NL-09-0635

Vogtle Electric Generating Plant
Second 10-year Interval Inservice Inspection Report
Request for Additional Information

**Vogtle Electric Generating Plant
Response to NRC Request for Additional Information
Regarding Relief Request 44 and 47 for the Second 10-Year Interval
Inservice Testing Program**

Weld 11201-005-8
Figure 1

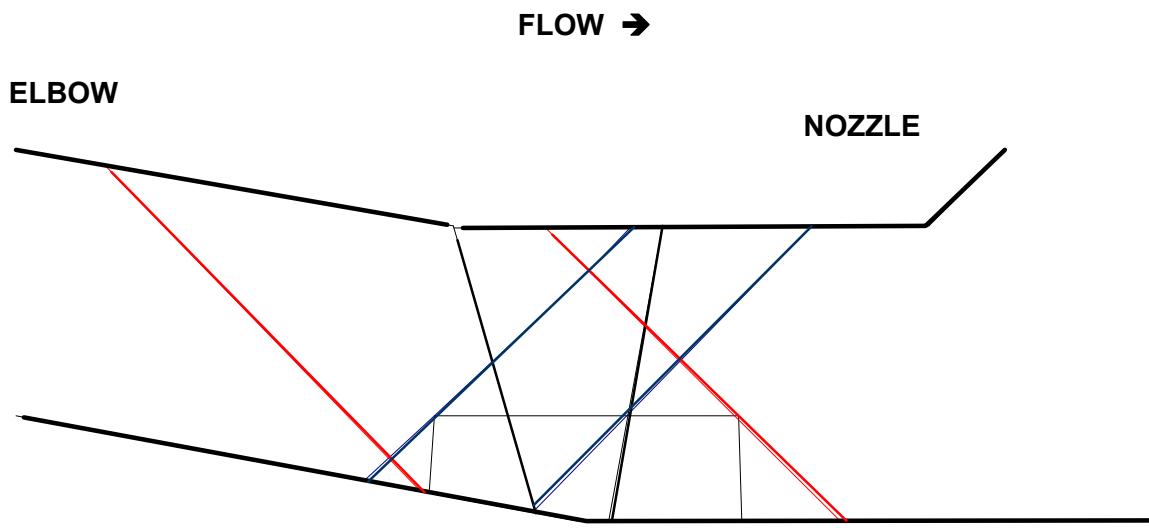
Weld 11201-005-8 joins a cast stainless steel elbow to a cast stainless steel pump nozzle. This weld was examined in 1999 (pre-Appendix VIII) using the requirements of Appendix III of the 1989 Edition of ASME Section XI, which requires that the examination volume receives two-directional coverage. An industry recommended 1 MHz 45° dual-element, Refracted Longitudinal (RL) Wave transducer was used for the examination of the cast stainless steel components and weld. Referencing Figure 1 (Figure 1 was drawn from a field sketch of the actual examination volume), when scanning from the elbow side for detection of circumferentially-oriented flaws there were no limitations and the coverage was 100%. However, when scanning from the nozzle side for detection of circumferentially-oriented flaws, the nozzle curvature prevented the transducer from being moved back to the extent necessary to pass the sound beam through the complete nozzle side examination volume. As a result, only about 60% of the volume was examined from the nozzle side, as depicted by the blue lines. Therefore approximately 80% of the examination volume received two-directional coverage and 20% received one-directional coverage when scanning for circumferentially-oriented flaws. When scanning for axially-oriented flaws there were no scanning limitations identified.

Because of the nozzle taper, it is considered impractical to obtain additional examination coverage using alternative methods or advanced technologies. This nozzle is an integral part of the overall pump casting and to appreciably increase the coverage would require replacement of the pump with one having a modified nozzle configuration.

Weld 11201-009-1
Figure 2

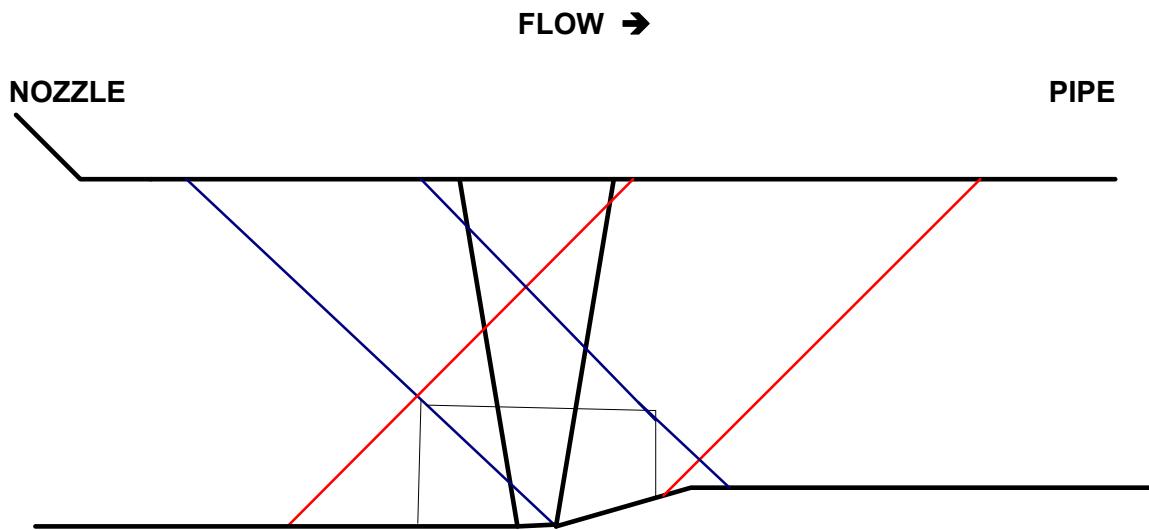
Weld 11201-009-1 joins a cast stainless steel pipe to a cast stainless steel pump nozzle. This weld was examined in 1999 (pre-Appendix VIII) using the requirements of Appendix III of the 1989 Edition of ASME Section XI, which requires that the examination volume receives two-directional coverage. An industry recommended 1 MHz 45° dual-element RL Wave transducer was used for the examination of the cast stainless steel components and weld. Referencing Figure 2 (Figure 2 was drawn from a field sketch of the actual examination volume), when scanning from the pipe side for detection of circumferentially-oriented flaws there was 100% coverage. However, when scanning from the nozzle side for detection of circumferentially-oriented flaws, the nozzle curvature prevented the transducer from being moved back to the extent necessary to pass the sound beam through the complete nozzle side examination volume. As a result, only about 60% of the volume was examined from the nozzle side, as depicted by the blue lines. Therefore, approximately 80% of the examination volume received two-directional coverage and 20% received one-directional coverage when scanning for circumferentially-oriented flaws. When scanning for axially-oriented flaws there were no scanning limitations identified.

Because of the nozzle taper, it is considered impractical to obtain additional examination coverage using alternative methods or advanced technologies. This nozzle is an integral part of the overall pump casting and to appreciably increase the coverage would require replacement of the pump with one having a modified nozzle configuration.

Weld 11204-023-15-RI
Figure 3

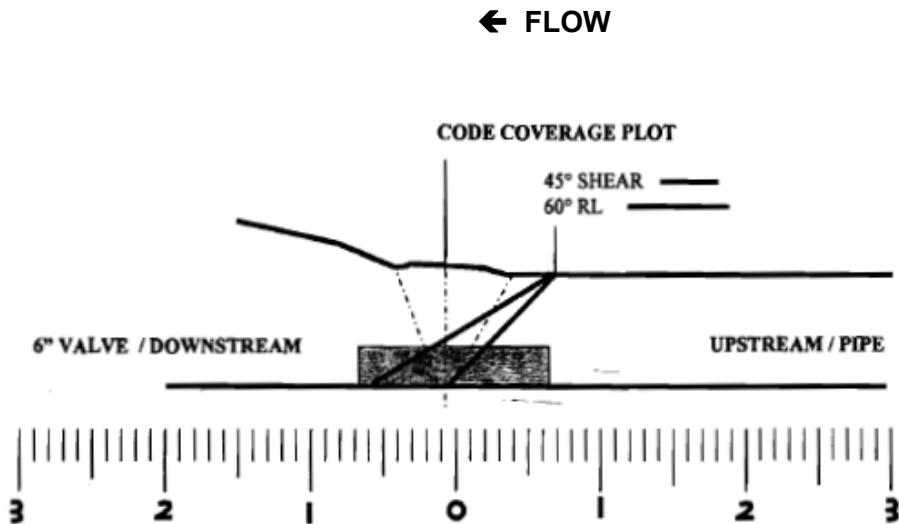
Weld 11204-023-15-RI is a 6" austenitic stainless steel pipe to valve weld that was examined in 2003 after the implementation of Appendix VIII; however, due to the valve taper examination was only performed from the pipe side. Additionally, when scanning from the pipe side of the weld, the transducer travel was stopped at the edge of the weld because of the weld configuration as shown in Figure 3. Weld crown conditioning was not performed because:

- Per Section 5.4 of Performance Demonstration Initiative (PDI) generic procedure PDI-UT-2, *the weld crown condition may be examined in the "as-welded" condition provided the "as-welded" crown width is not excessive. Excessive "as-welded" crown width is defined as when the weld crown width is greater than 3 times the nominal material thickness or when the weld crown condition prohibits adequate volumetric coverage from the base material surface in either the axial or circumferential scanning directions (e.g., weld repair sites, excessive or offset weld width or reinforcement on one side of the weld).* The weld crown width was not considered to be excessive.

- For austenitic welds, 10 CFR 50.55a(b)(2)(xv)(A)(2) requires that when examination from both sides is not possible (as is the case for this weld), full coverage from a single side may be claimed only after completing a successful single-sided Appendix VIII demonstration using flaws on the opposite side of the weld. Since the industry has not qualified single-sided examinations, SNC cannot claim Code coverage on the far side of the weld. Therefore, the maximum Code coverage is 50%. While weld crown reduction may have improved the ability to scan over the weld, Code coverage would not have increased.

As described above, 50% Code coverage is the maximum coverage for this weld; however, as described in Figure 3, only 15" of the required 19" of the required area was scanned on the pipe side due to support steel interference. This interference reduced the Code coverage to 40%.

In addition to the 45⁰ shear wave, a 60⁰ RL-wave transducer was used as a supplemental examination to scan for circumferentially-oriented cracking on the far side of the weld and no flaws were detected. This 60⁰ RL-wave examination could not be credited for Code coverage on the far side of the weld; however, it did provide additional assurance of the structural integrity of the weld.

Because examinations have not been qualified for the far side of the weld, it is considered impractical to obtain additional examination coverage using alternative methods or advanced technologies. As this time, to appreciably increase coverage, replacement of the valve with one having a modified configuration to allow examination from both sides would be required.

The best available techniques, as qualified through the Performance Demonstration Initiative for Supplement 2 with demonstrated best effort for single side examination was used from the accessible side of the weld. In addition, only 15" of the 19" of required area was scanned on the pipe side due to support steel interference. 40% was given to the weld for Code Coverage (A generic 50% minus 10% of unscanned area on the pipe side).

Welds 21204-023-15R-RI and 21204-023-16R-RI
Figure 4

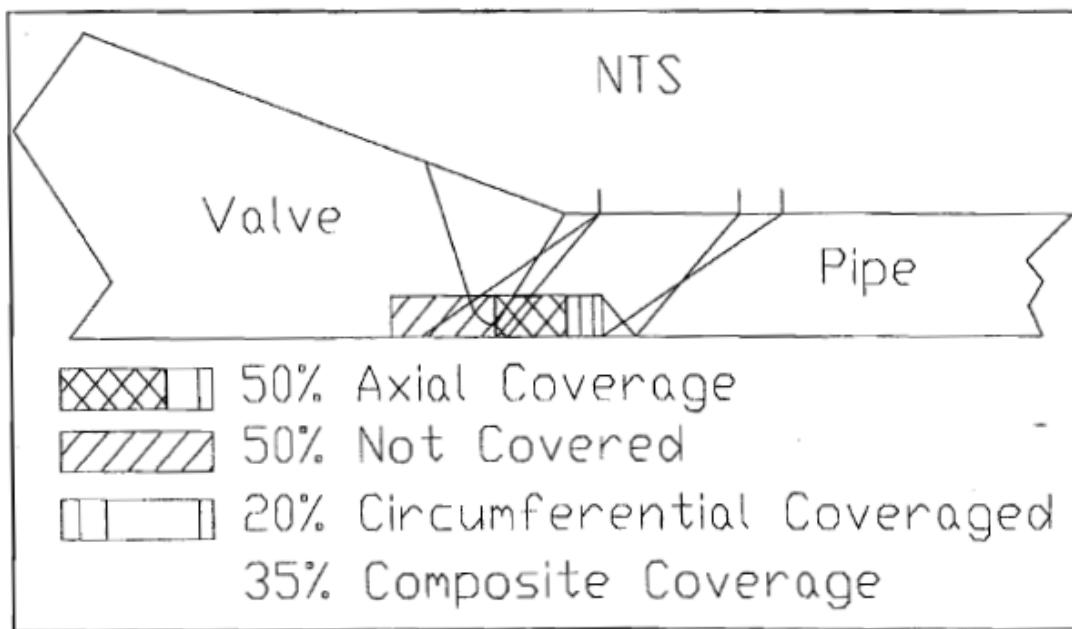
Welds 21204-023-15R-RI and 21204-023-16R-RI are 6" austenitic stainless steel pipe to valve welds. These configurations are essentially identical and the discussion below applies to both welds.

The weld was examined in 2007 after the implementation of Appendix VIII; however, the configuration only allowed examination from the pipe side due to the valve and weld taper. Additionally, when scanning from the pipe side of the weld, the transducer travel was stopped at the edge of the weld because of the sharp taper as shown in Figure 4. Therefore, the 45⁰ shear wave examination was limited to approximately 50% coverage when scanning for circumferentially-oriented flaws and approximately 20% coverage when scanning for axially-oriented flaws.

In addition to the 45⁰ shear wave, a 60⁰ RL-wave transducer was used as a supplemental examination to scan for circumferentially-oriented cracking on the far side of the weld and no flaws were detected. However, this 60⁰ RL-wave examination could not be credited for coverage on the far side of the weld because of the requirements set forth in 10 CFR 50.55a(b)(2)(xv)(A)(2). Per 10 CFR 50.55a(b)(2)(xv)(A)(2), when examination from both sides of an austenitic weld is not possible, full coverage from a single side may be claimed only after completing a successful single-sided Appendix VIII demonstration using flaws on the opposite side of the weld. Since the industry has not qualified single-sided examinations for austenitic welds, SNC cannot claim Code coverage on the far side of the weld. However, this supplemental examination did provide additional assurance of the structural integrity of the weld.

The weld was evaluated for weld crown conditioning and it was determined that it would not appreciably increase the coverage because of the tapered configuration. Because of this taper, it is considered impractical to obtain additional examination coverage using alternative methods or advanced technologies. To appreciably increase coverage, replacement of the valve with one having a modified configuration to allow examination from both sides would be required.
